1803 Rhode Island Ave, NE Washington DC

REVISED DESIGN (2022)

Board of Zoning Adjustment
District of Columbia
CASE NO. 2021-14
ST-EX-18-013
upwall

3rd Floor Level

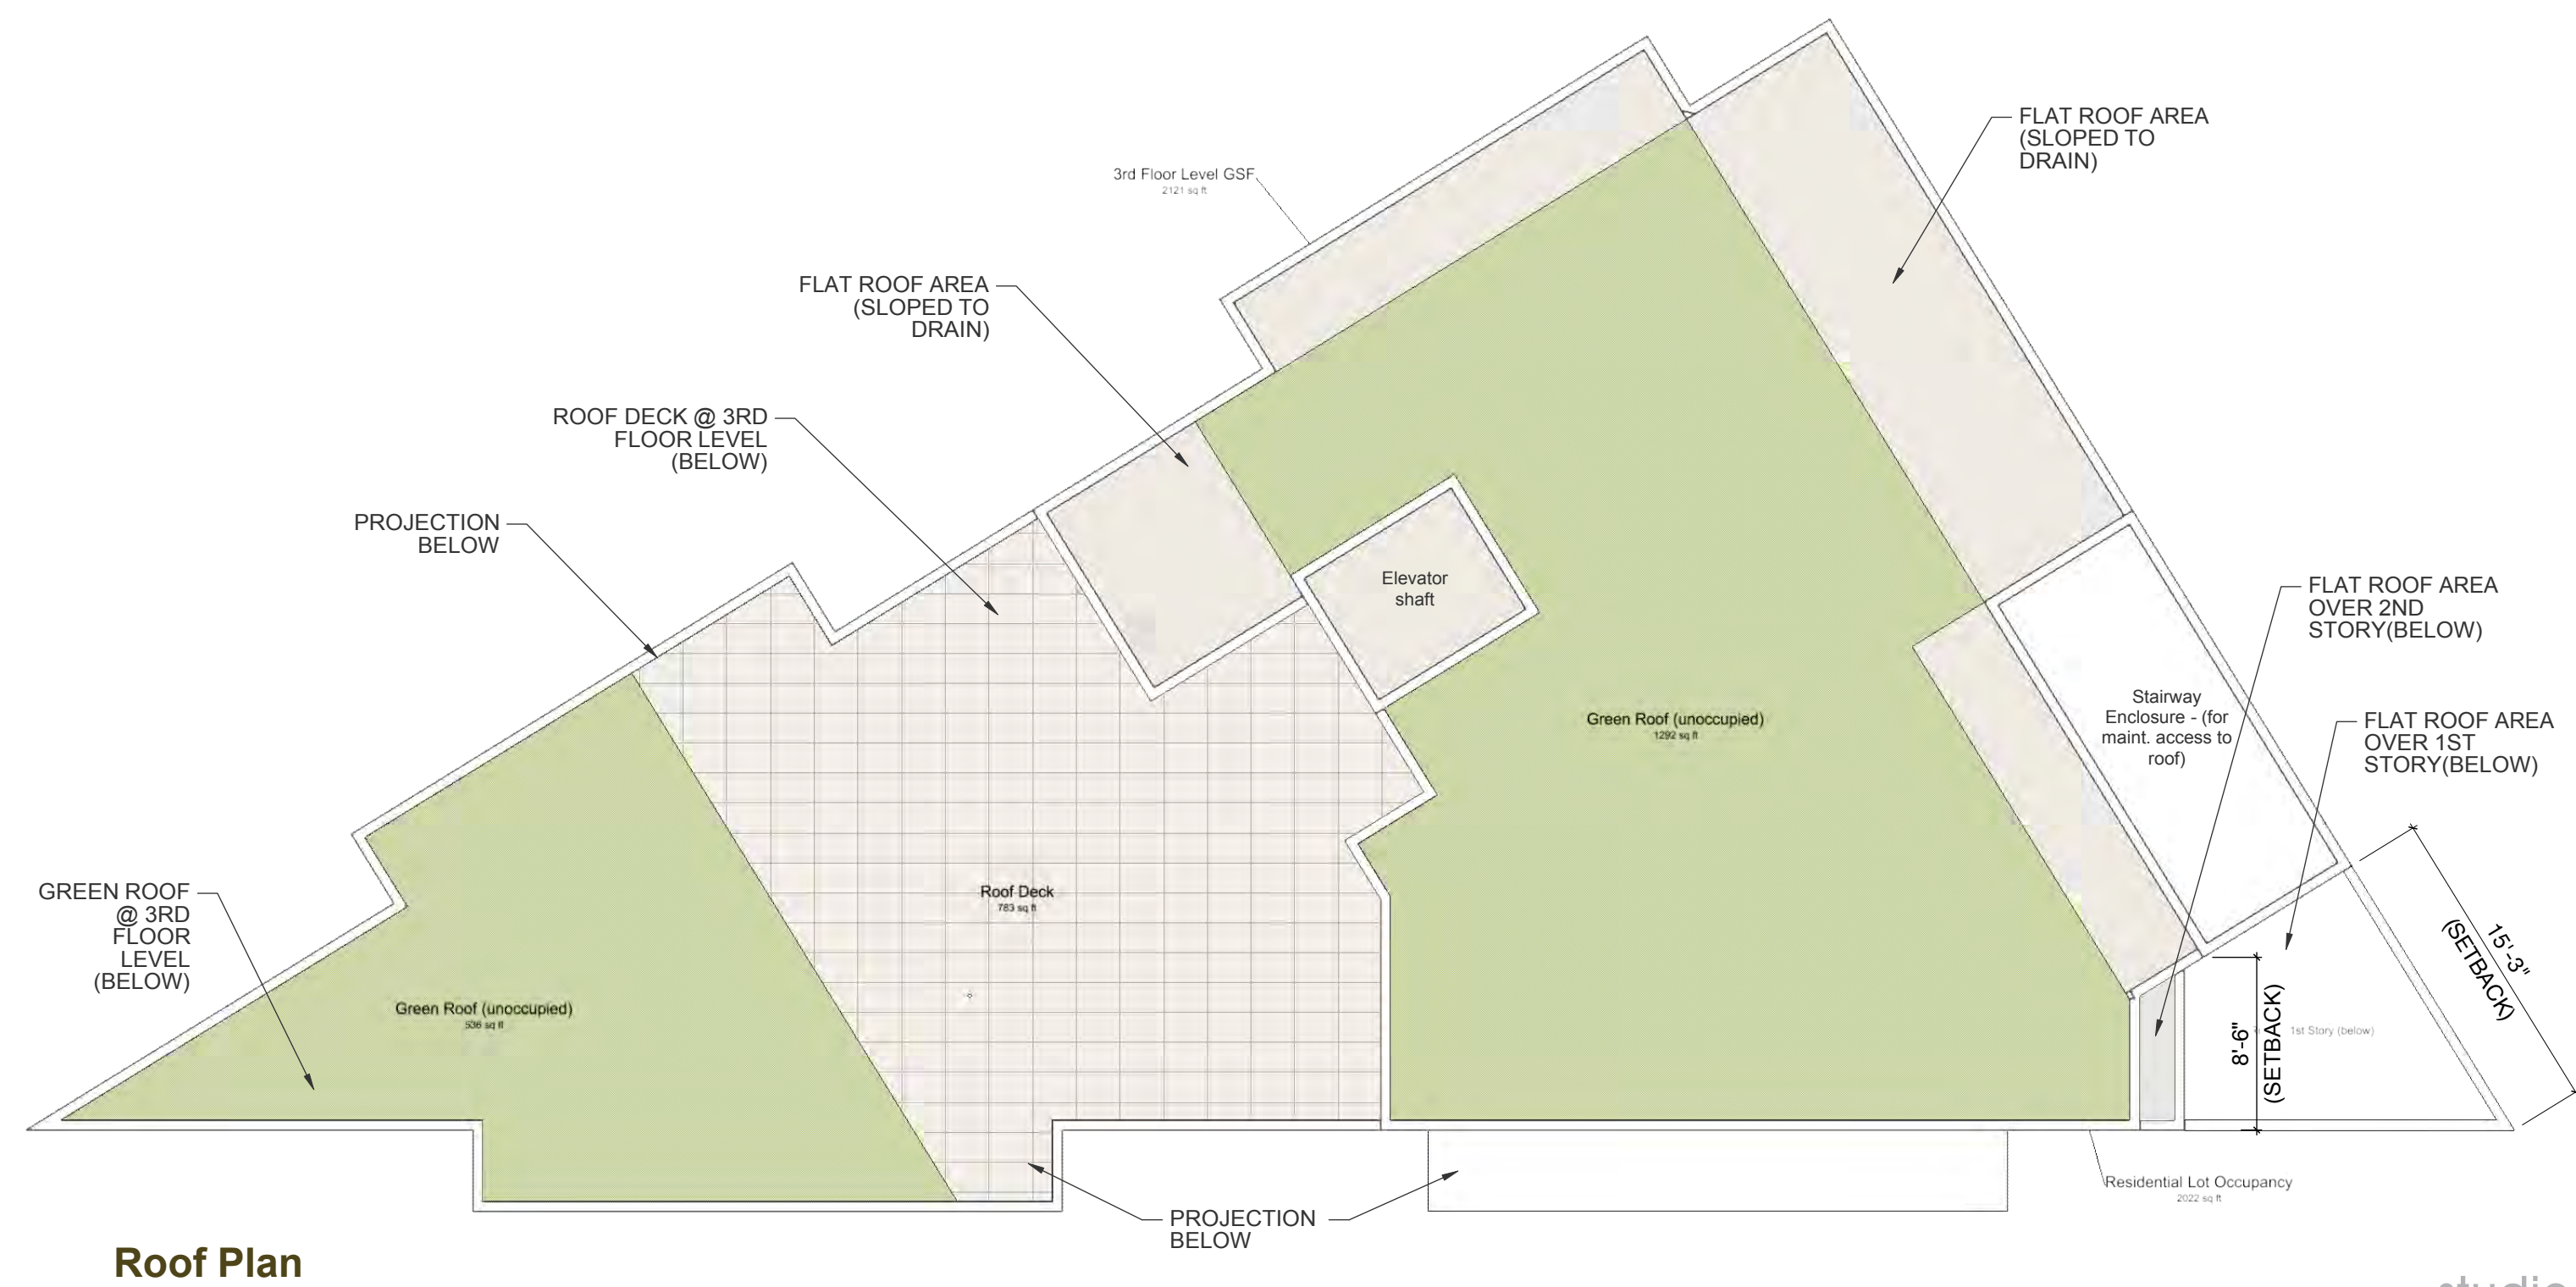
PROPOSED USE AT 3RD STORY CHANGED FROM (2) RESIDENTIAL UNITS TO (4) RESIDENTIAL UNITS

STAIRWAY SERVING RESIDENTIAL UNITS

Roof Plan

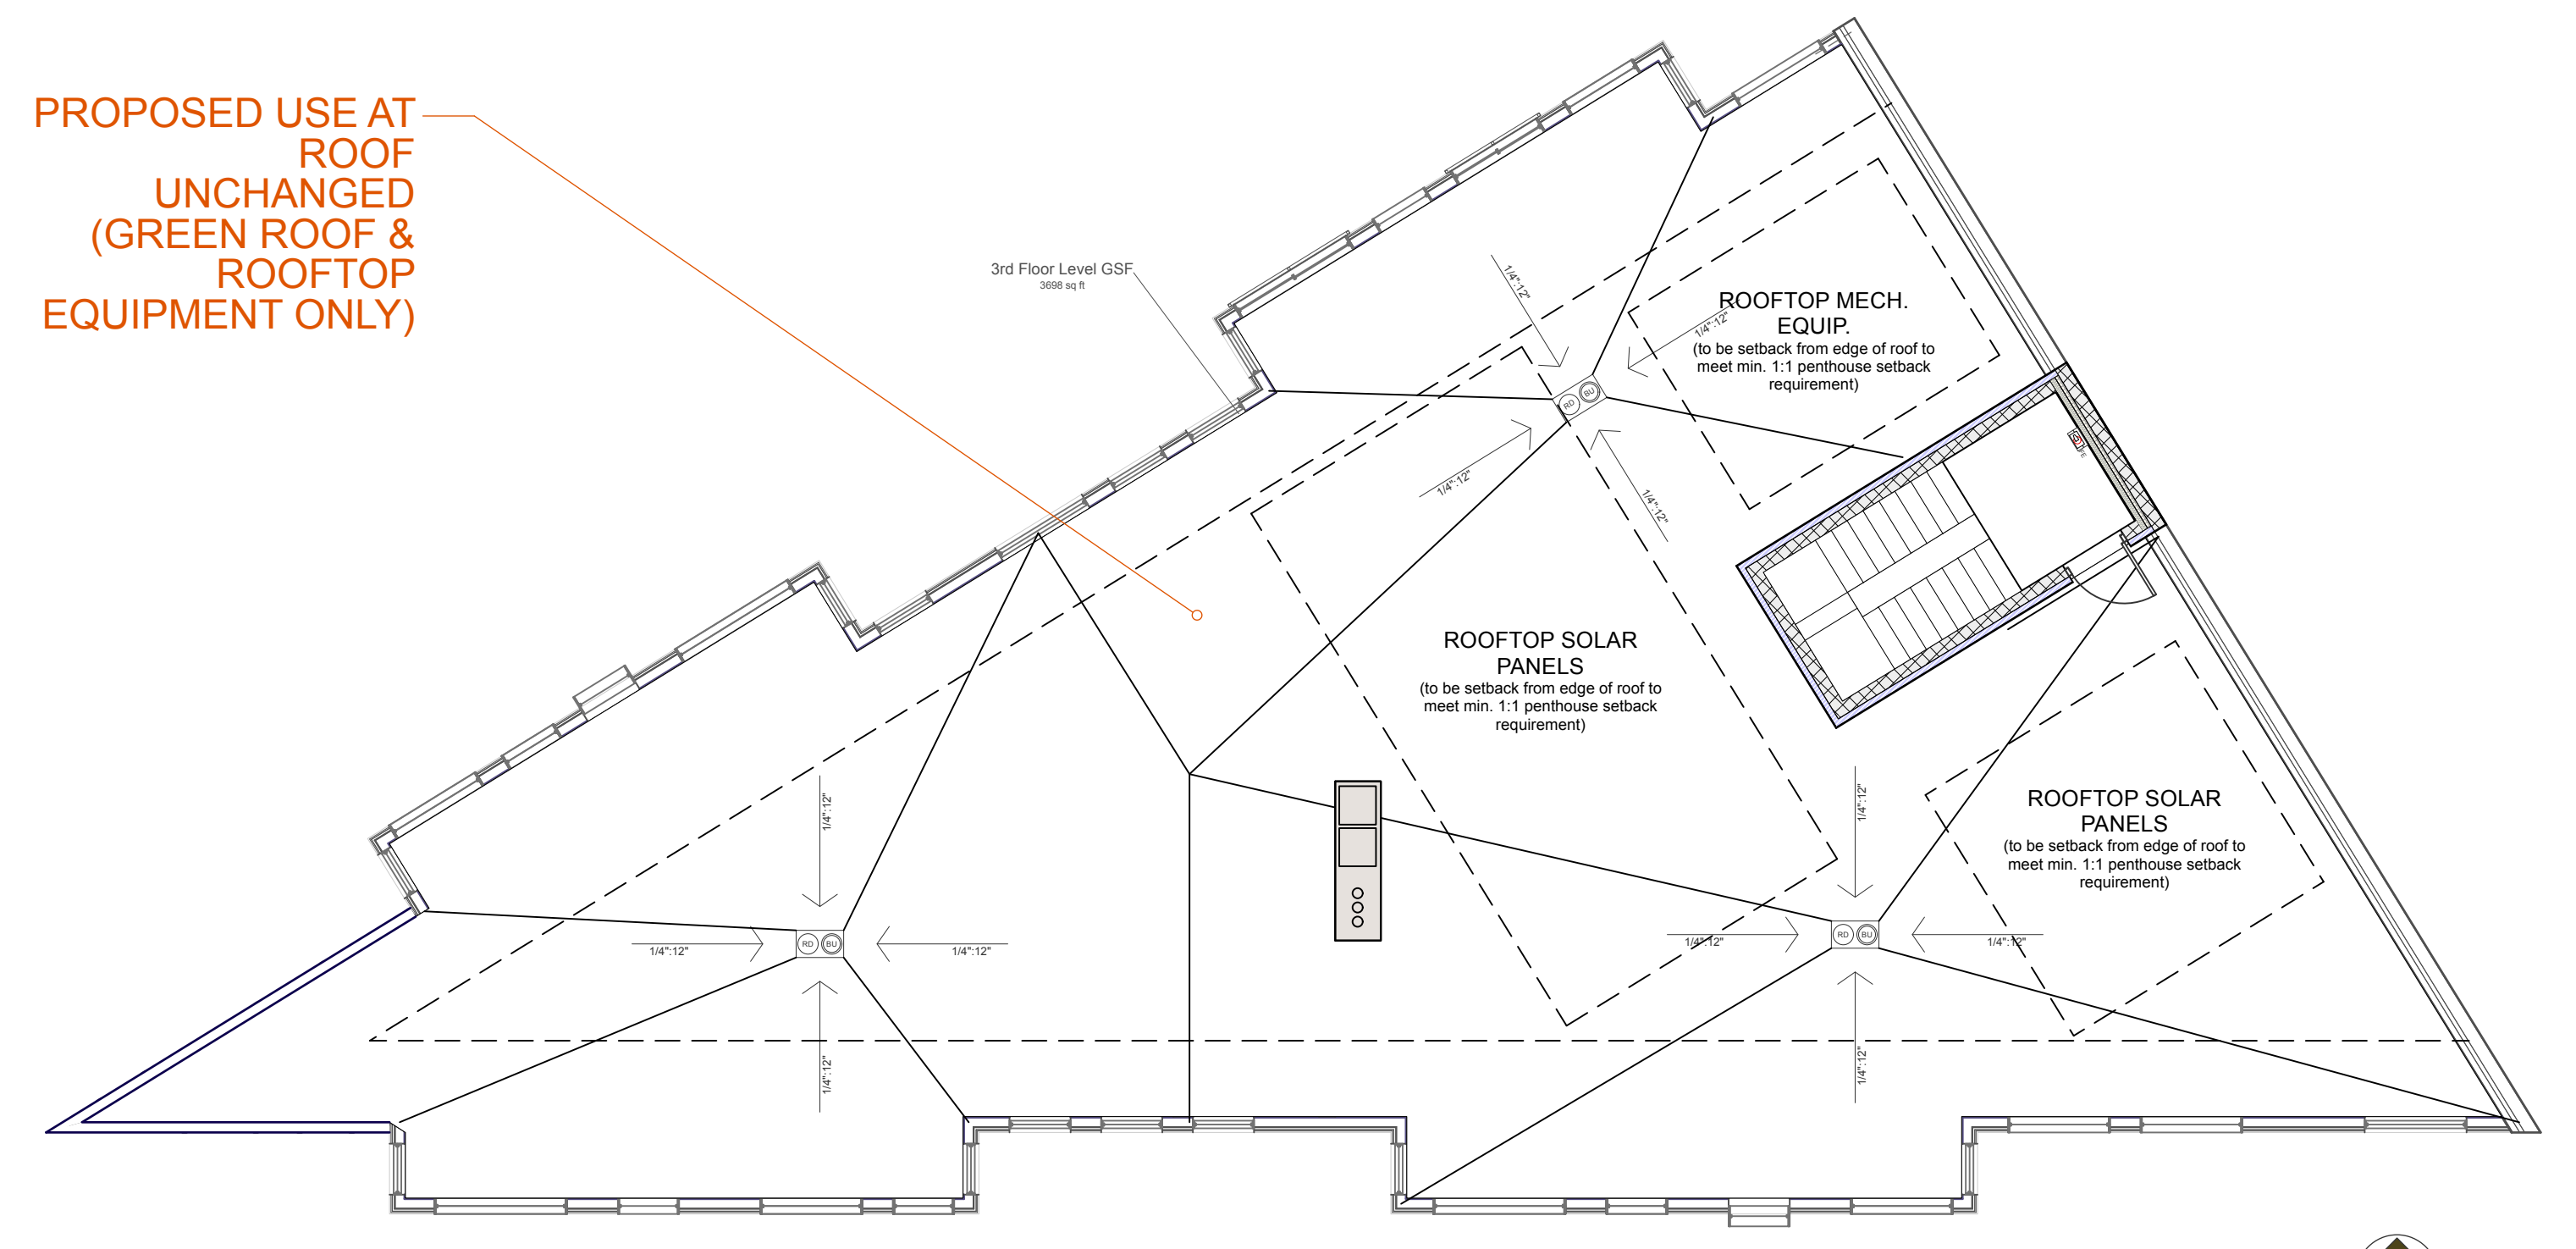
REVISED DESIGN (2022)
